Echotex Ltd. (Extension 2)

Chandra Pollibiddut, Kaliakoir, Gazipur-1751, Bangladesh

11 March 2024

2. Observations:

Overstressed columns

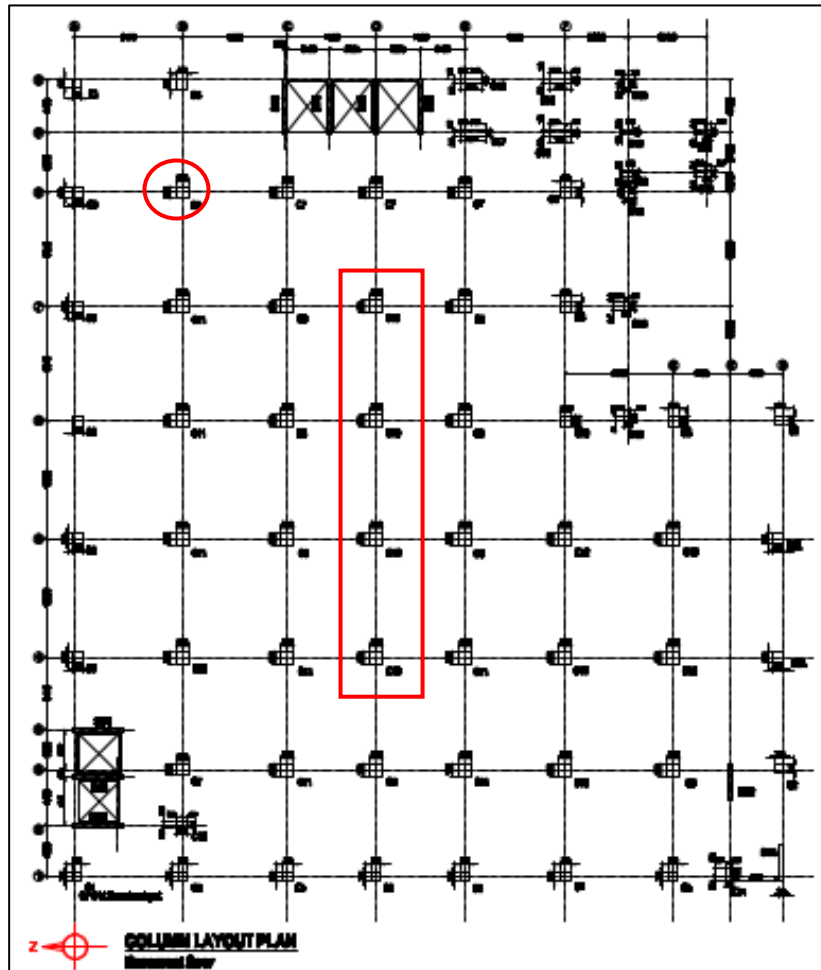
Observation 1: Cursory calculation indicates the columns are marginally overstressed (Multi-Purpose Building- 2).

Description: The cursory calculation indicates that marked columns are stressed above the normal design limit considering floor live load 4kPa for the typical floors and 6kPa for storage floors. We have considered minimum concrete strength (16.3 MPa) based on aggregate type and rebar strength 415 MPa.

The building engineer is required to review the design, load, and column stresses based on-situ material strength and produce an EA report as per BNBC 2020.

Steel Storage Rack – Not Anchored

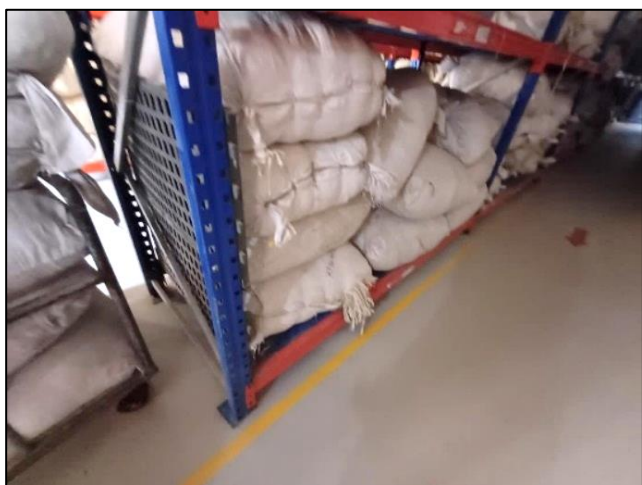
Observation 3: Non-structural element found unbraced or non-anchored (Multi-Purpose Building- 2)

Plastic Water Tank – Not Braced

Description: Steel storage rack on several floor and plastic water tanks at roof were found non-anchored/unbraced. Factory is required to anchor or brace all non-structural elements (rack, plastic water tank etc.).

Column layout

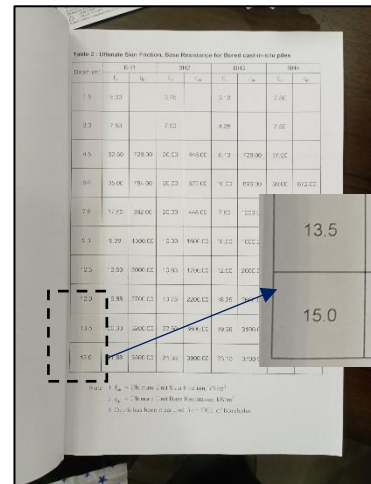
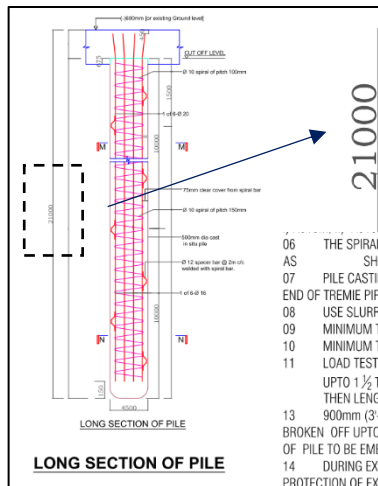
Observation-5: Column appears to be slender (Office Building).

Description: Cursors calculation shows that slenderness in highlighted columns exceeds the normal design limit due to long unsupported lengths. The building engineer is required to carry out an adequacy check of the highlighted columns considering the slenderness effect.

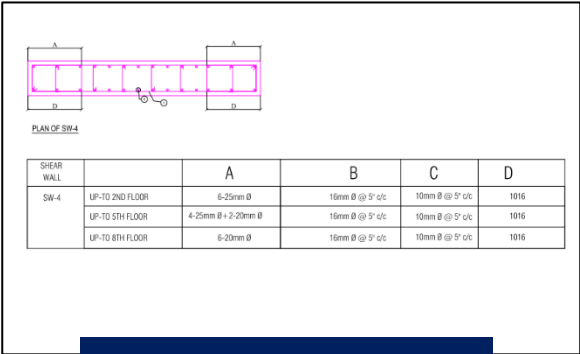
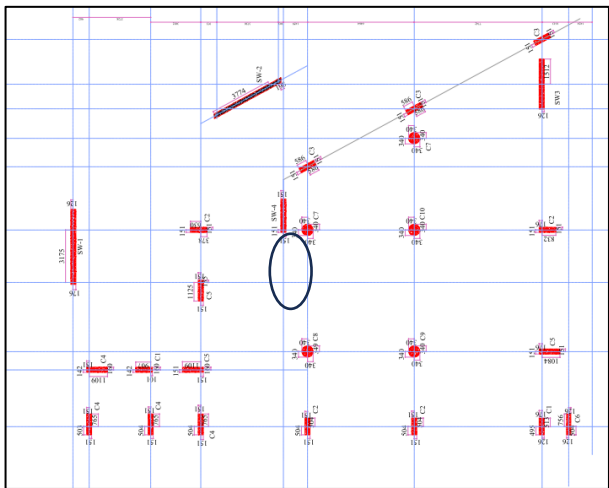
Observation-6: Lack of geotechnical data (Office Building).

Description: As per the provided drawing, the length of the pile is 21 m, but pile capacity is provided up to 15 m only in the soil test report. A geotechnical engineer is required to investigate this issue and prepare a new soil test report up to 21 m in length.

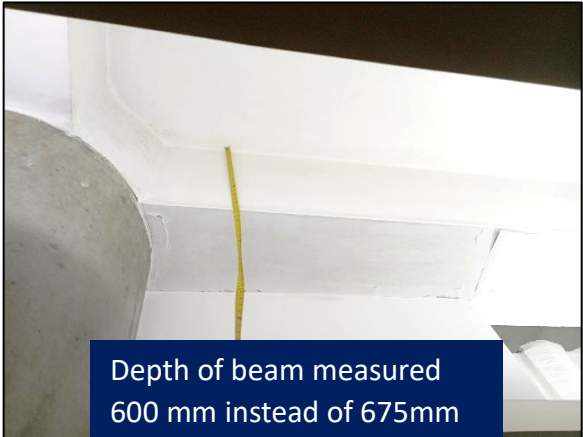
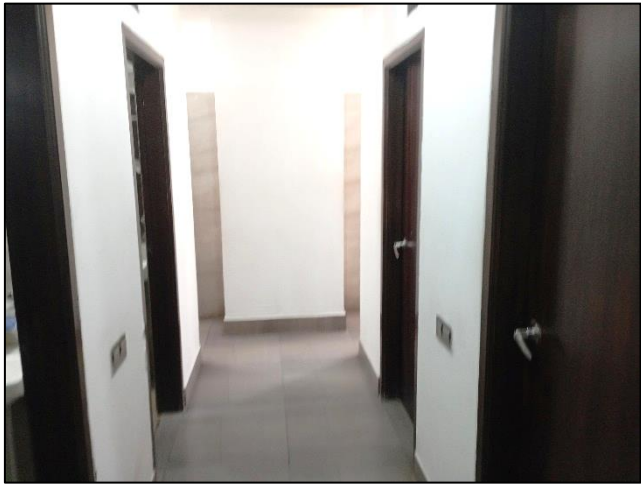
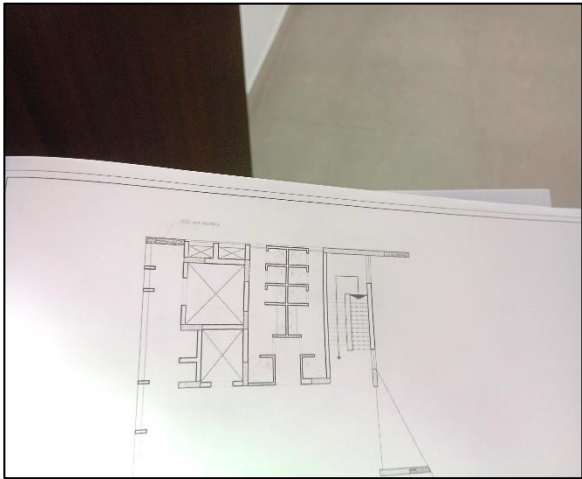
Observation-8: Discrepancy and missing information in as-built drawing (Office Building).

Details of shear wall is not provided in drawing.

Depth of beam measured 600 mm instead of 675mm

Description: Shear wall at marked location was not found at top floor. No details of shear wall is provided in structural drawing. The depth of beam was measured 600 mm instead of 675mm. Toilet arrangement was not found as per as-built drawing. The building engineer is required to update the as-built drawing.

Overstressed columns and footings

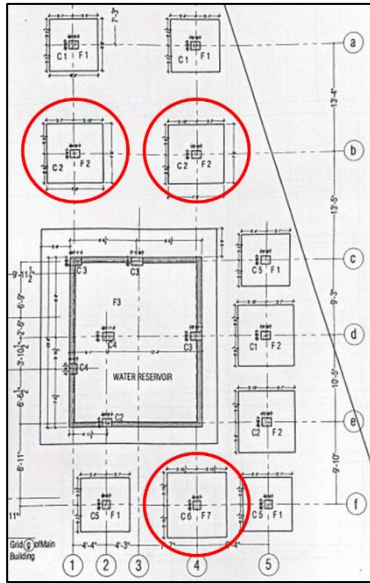
Observation 9: Cursory calculation indicates the columns and foundations are marginally overstressed (Old Utility Building)

Description: The cursory calculation indicates that marked columns and foundations are stressed above the normal design limit considering floor live load 2kPa for the typical floors. We have considered minimum concrete strength (14.1 MPa) based on aggregate type and rebar strength 275 MPa.

The foundations are marginally overstressed for punching shear and not checked for bearing as no soil investigation report was available. The building engineer is required to review the design, load, and column-foundation stresses based on-situ material strength at the marked locations.

Roof plan

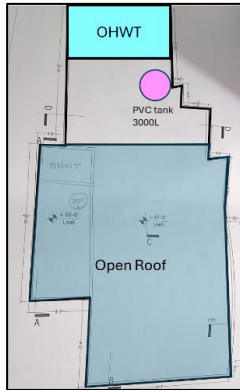
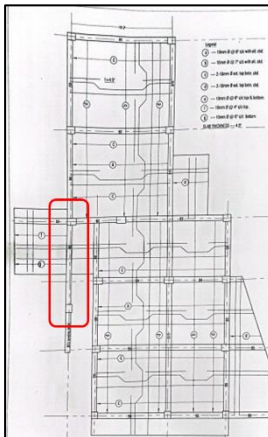
Observation 10: Inconsistencies in the as-built drawing (Old Utility Building)

Overhead water tank at roof

PVC water tank at the roof

Steel roof top shed

Steel stair

Discontinuous rooftop beam

Floor Build up and false slab

Description: During the inspection, the mismatch was found in the as-built drawings of the Old Utility building. On the roof, an overhead water tank and a PVC water tank (3000L) were found not mentioned in the drawing. The structural drawing of OHWT was found missing. Floor build-up and false slab are not mentioned in the drawing. The rooftop of the marked portion is a steel shed. No structural details were found for the steel portion. There is a steel stair with the building. No drawing was available for the stairs. There is a discontinuous beam at the rooftop. No rooftop beam layout/structural details were provided. The building engineer is required to survey the structure, prepare accurate as-built drawings, and submit to the RSC.

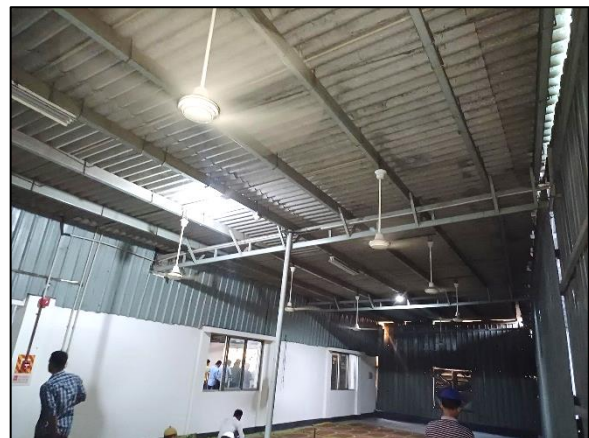
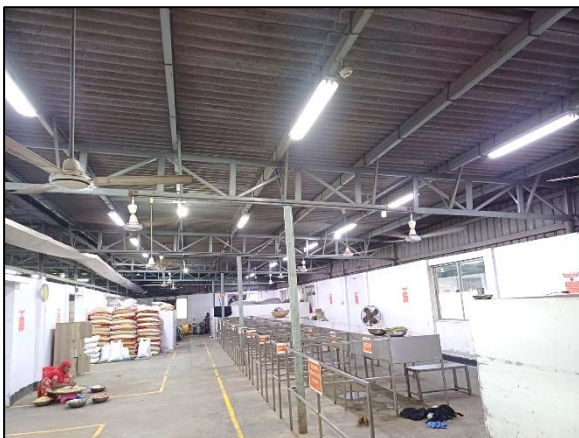
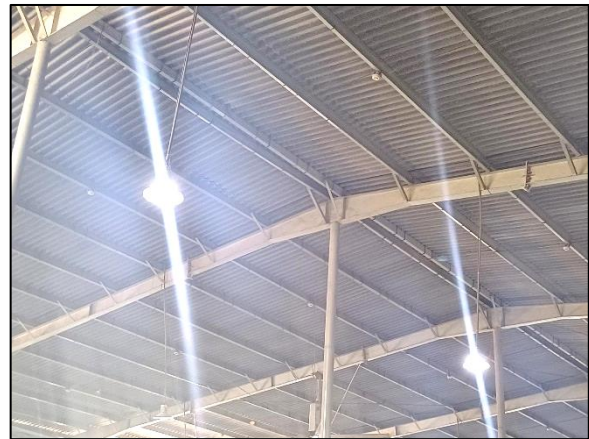
Observation 16: Lack of lateral stability (Dining Shed)

Description: During the inspection, a lack of lateral stability was found in the Dining Shed. Lateral load transfer media are absent (Compression Strut) along the transverse direction of the rafters. There is no compression strut, vertical and horizontal bracing transverse to the truss members of the shed. The building engineer is required to carry out an Engineering Assessment (EA) to check the lateral stability of the structure and suggest proper remedial actions accordingly. Submit the EA documents to RSC for review.

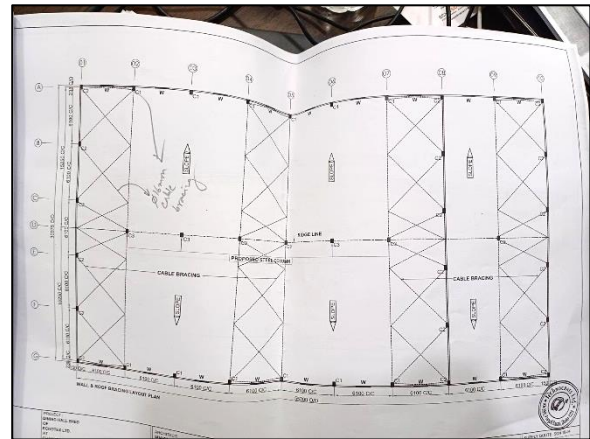
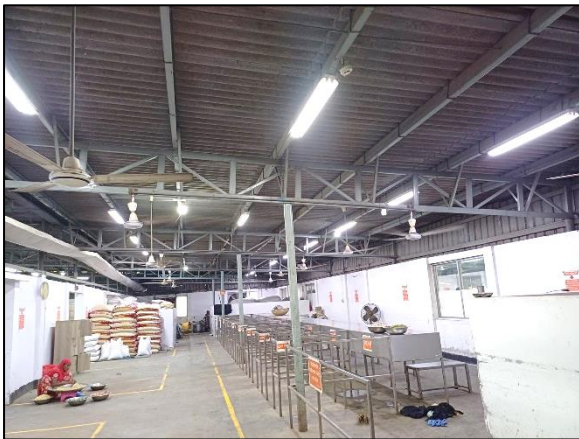
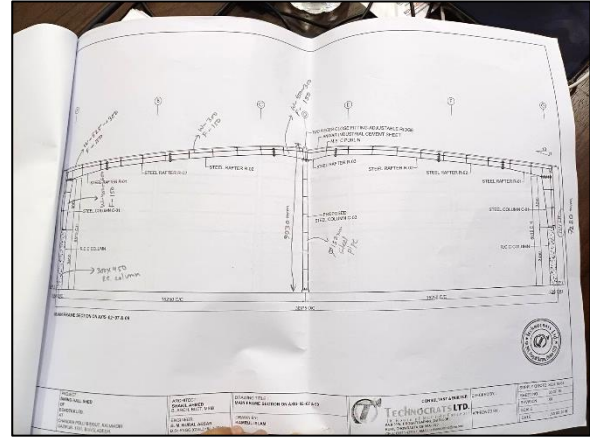
Observation 17: Lack of information in the as-built drawing. (Dining Shed)

Description: Lack of information was found in the as-built drawings of the Dining Shed. The size of the steel column, rafter, vertical and side wall bracings, RC column and tie beams were found missing in the drawings. Structural details of truss members and supporting steel columns in the dining, prayer and washing sections were not found. There is also the absence of connection details. The building engineer is required to survey the structure, prepare accurate as-built drawings, and submit to the RSC.

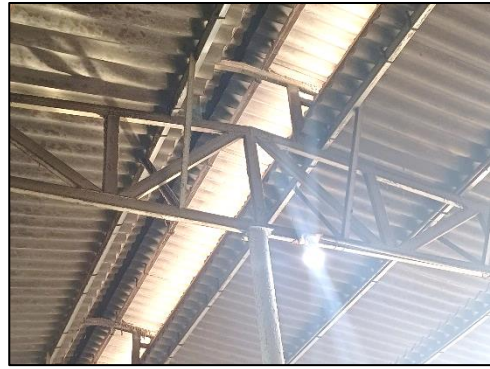
Observation 19: Lack of lateral stability (Kitchen Shed)

Description: During the inspection, a lack of lateral stability was found in the Kitchen Shed. Lateral load transfer media are absent (Compression Strut, Vertical and Horizontal Bracing) along the transverse direction of the truss. There is an improper steel connection, and the foundation system is also not clear. The building engineer is required to carryout an Engineering Assessment (EA) to check the lateral stability of the structure and suggest proper remedial actions accordingly. Submit the EA documents to RSC for review.
